Product Change Notice

PCN Number: P210402		Revision: A		Date of Publication: 01/29/2021
PRODUCT NAME	PRODUCT PART#	OLD — REV. — NEW		REVISION TYPE
RX370Q	71601-IA	1.0	1.1	Hardware

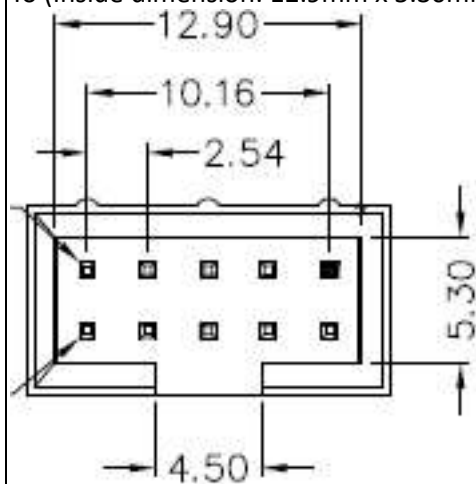
Current header shroud connector for the USB and Front Panel have been discontinued.

Change header shroud at locations: FP_USB2_1, FP_USB2_2, FP_USB2_3 and J_FIO_1.
From (Inside dimension: 12.9mm x 6.5mm)

To (Inside dimension: 12.9mm x 5.30mm)

BCM is recommending customers to check the dimensions of any mating cables that use these USB and Front Panel headers.
